Network Camera Firmware

Version: V5.5.80

Release Note (**External**)

(2018-09-13)

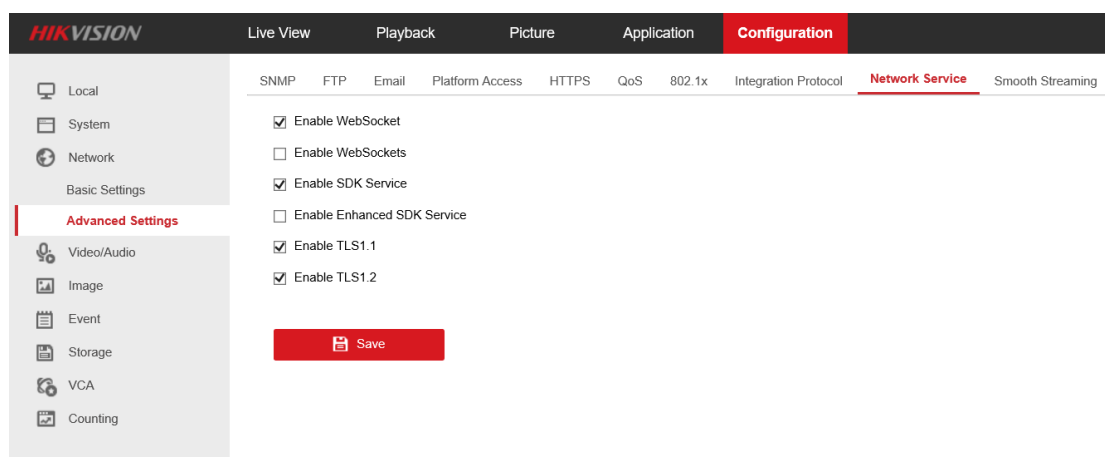
- Support HTTPS and is enabled by default. The status of HTTPS will keep same as before if

restoring the device. Only default operation will change the HTTPS status to be enabled as default, HTTPS skip automatically is supported and is disabled by default. Newly add the HTTPS port mapping

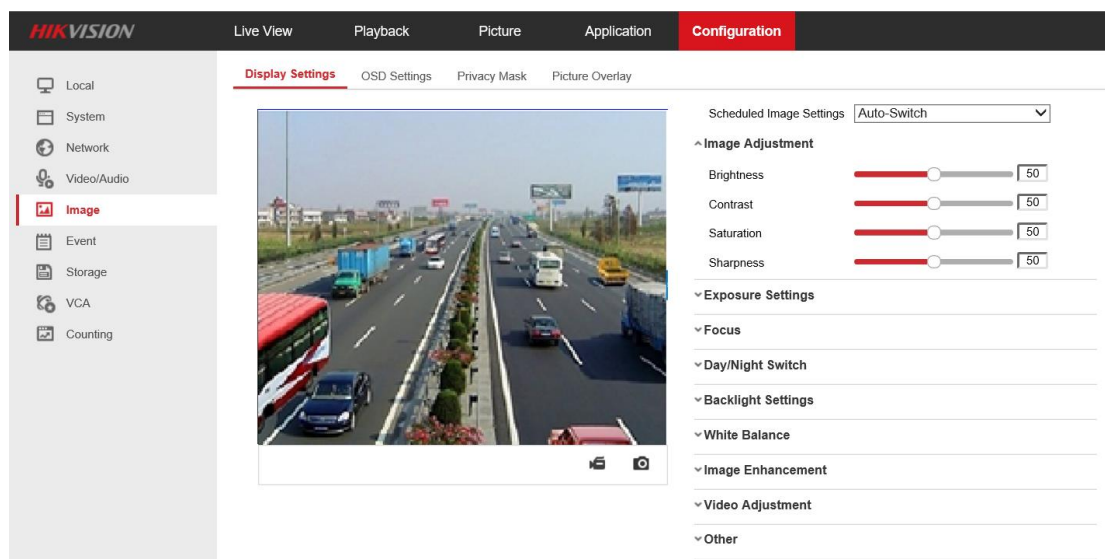
- ONVIF is disabled by default. The status of ONVIF will keep same as before if restoring the device. Only default operation will change the ONVIF status to be disabled as default.
- Newly add TLS1.1 and TLS1.2 Enable selection box. TLS1.1 and TLS1.2 is enabled as default. After restore or default, TLS1.1 and TLS1.2 will be back to enable status. TLS1.0 is unsupported. For compatibility reason, Email, Wi-Fi and 802.1x are still support TLS1.0. TLS1.1 and TLS1.2 cannot be disable at the same time. When disable TLS1.1 and TLS1.2 at the same time, it will show Device error.

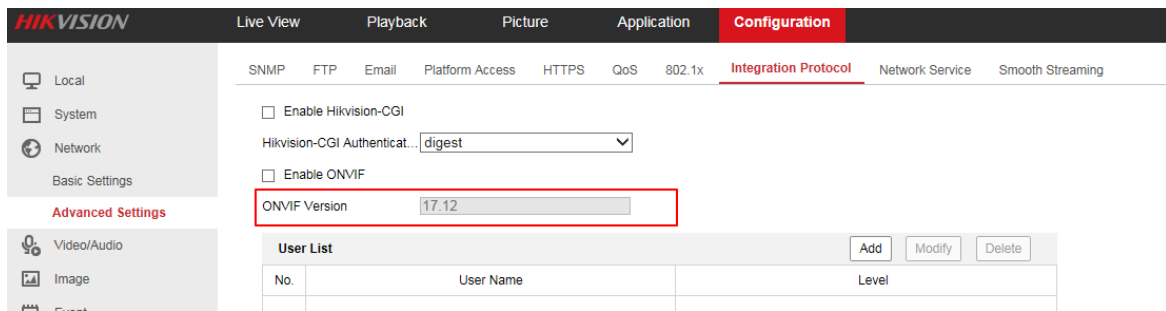
- The series port debug command has been changed from zhimakaimen to debug
- Newly add 'Start Recording' and 'Capture' bottom on Web-Configuration-Image interface, to save picture or clip to local.

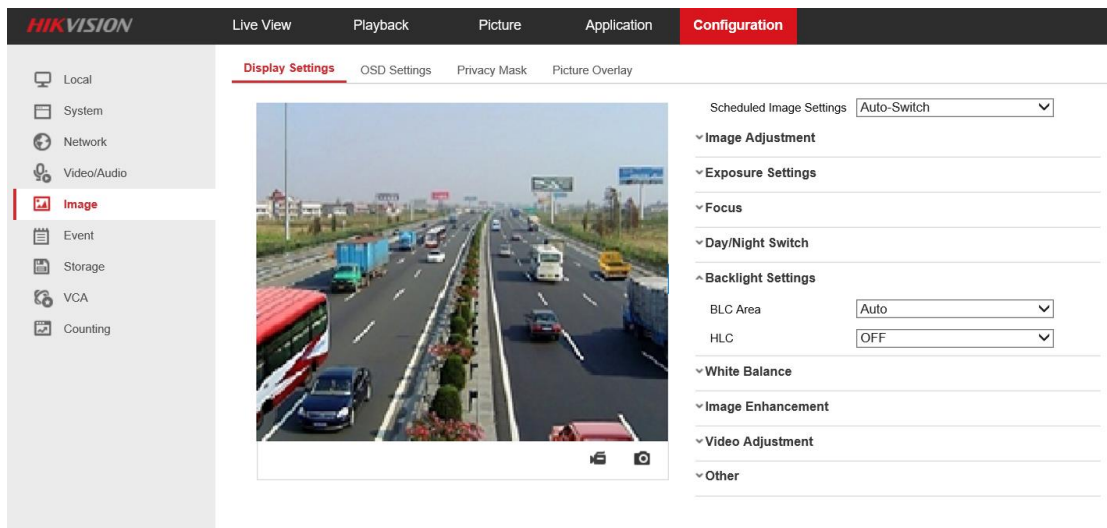
- The ONVIF version can be checked in the web interface
